Boulder Creek Hydrologic Analysis

Phase 2: Boulder Creek above St. Vrain Creek

Prepared for
Colorado Department of Transportation

June 10, 2015

FIGURE 4
Peak Discharge Estimates and Gage Locations
 CDOT Flood Recovery Hydrologic Evaluation

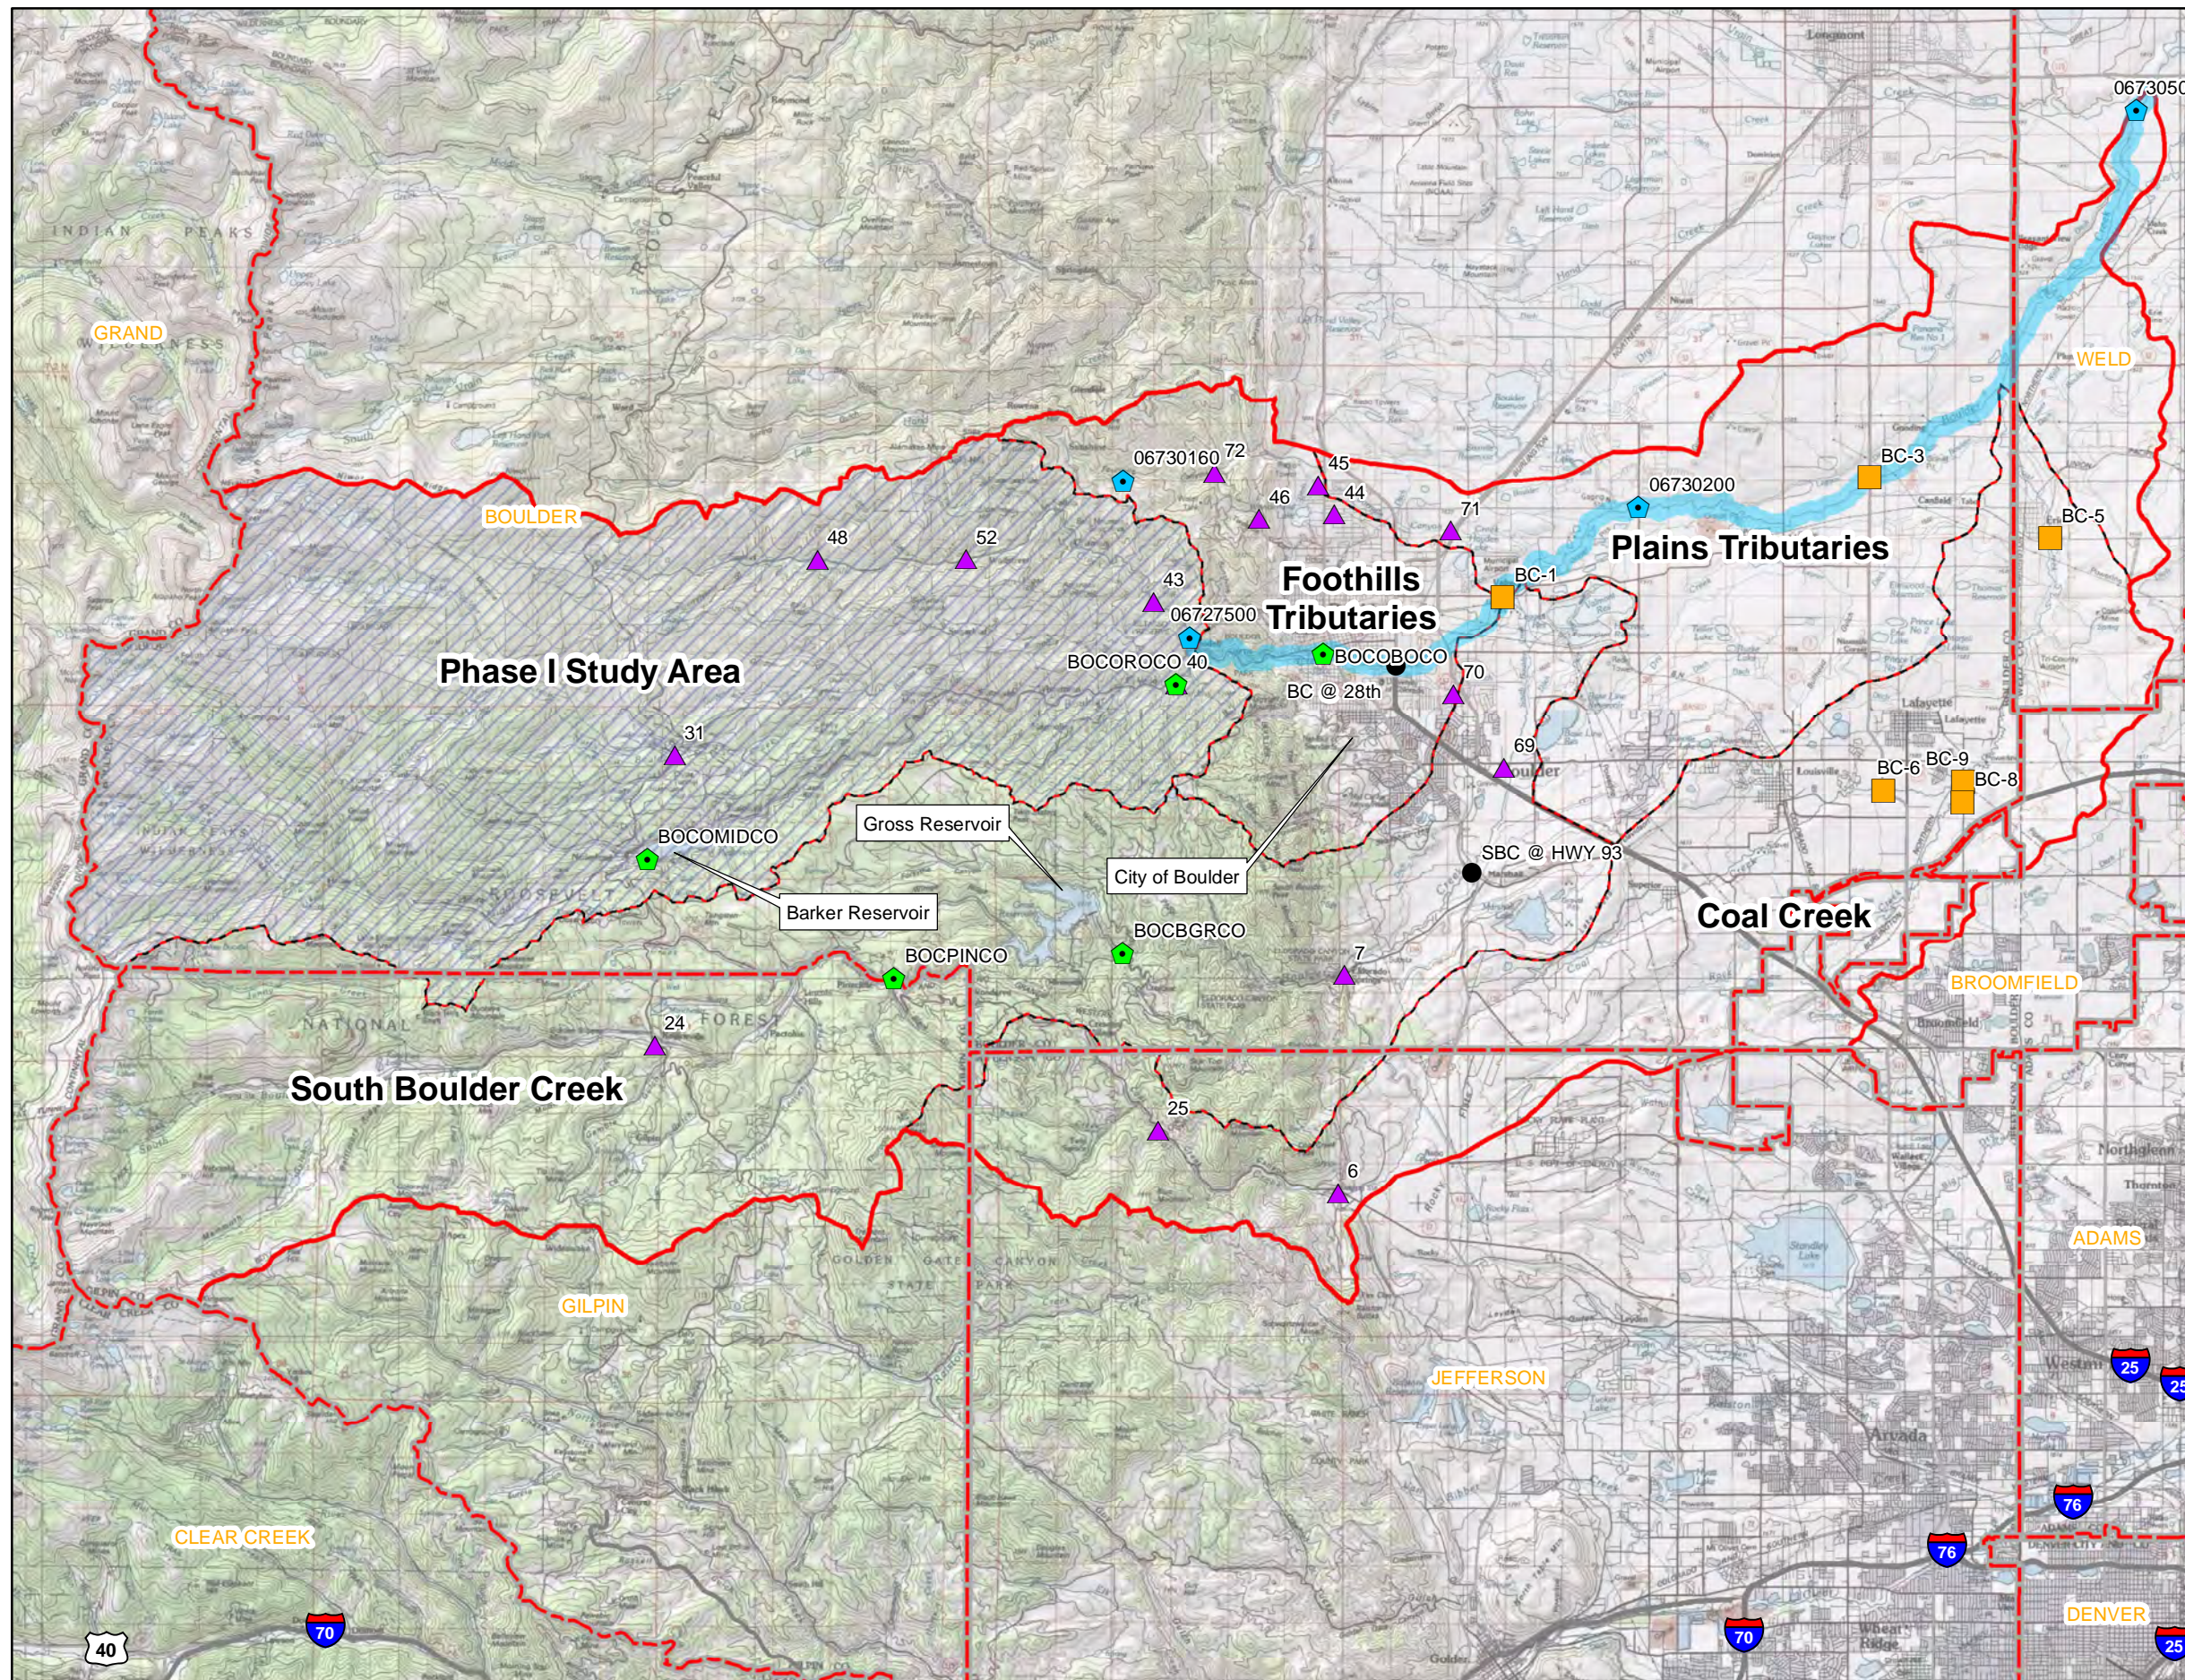
- 18. Comment:** Summary of Modeling approaches. In section 2.3 on page 25, the paragraph describes Peak Discharge estimates in Figure 3, but I believe it’s in Figure 4.
